Access Compliance Report Public Rights-of-Way (Curb Ramps)

Main Street: N_SELLAS_RD Cross Street: SIENNA_PKWY Location: SE

ADA ID: RPRK211109124838 Ramp Type: Type 1 - Perpendicular Initial Pass/Fail: Fail Overall Compliance: No Severity Score: 15

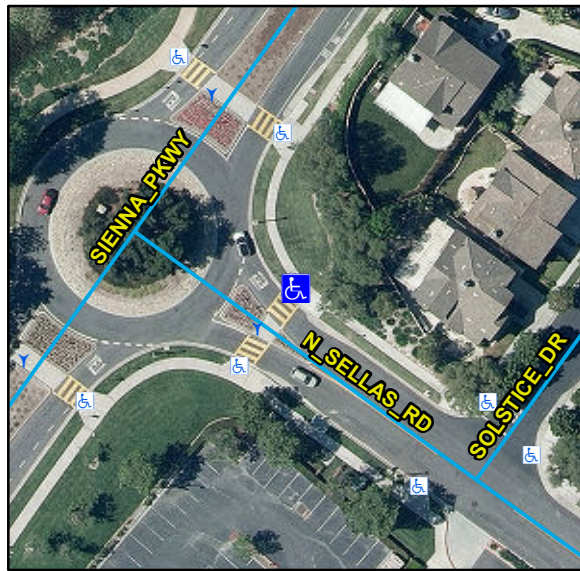
Compliance	Description	Data	Compliance	Description	Data
N/A	Ramp Length (in)	67	N/A	Flare Type LT	
Yes	Ramp Width (in)	48			N/A
No	Ramp Run Slope (%)	9.8	N/A	Flare Slope LT (%)	N/A
Yes	Ramp Cross Slope (%)	1.3	N/A	Flare Traversable LT	N/A
N/A	Landing Present	N/A	N/A	Flare Type RT	
N/A	Landing Length (in)	N/A			N/A
N/A	Landing Width (in)	N/A	N/A	Flare Slope RT (%)	N/A
N/A	Landing Run Slope (%)	N/A	N/A	Flare Traversable RT	N/A
N/A	Landing Cross Slope (%)	N/A	N/A	DWS Provided	N/A
N/A	Landing Movement Obstructed?	N/A	N/A	DWS Contrast	N/A
	Landing Movement Type	N/A	N/A	DWS Length (in)	N/A
N/A	Landing Shared	N/A	N/A	DWS Full Width	N/A
N/A	Clear Space	N/A	N/A	DWS Offset Left (in)	N/A
N/A	Clear Space To Crosswalk (in)	N/A	N/A	DWS Offset Right (in)	N/A
N/A	Marked Crosswalk 1	Yes	N/A	Marked Crosswalk 2	N/A
	Crossing 1 Direction	SW		Crossing 2 Direction	N/A
	Marked Crosswalk 1 Width (in)	144		Marked Crosswalk 2 Width (in)	N/A

Remove & Replace Entire Ramp.
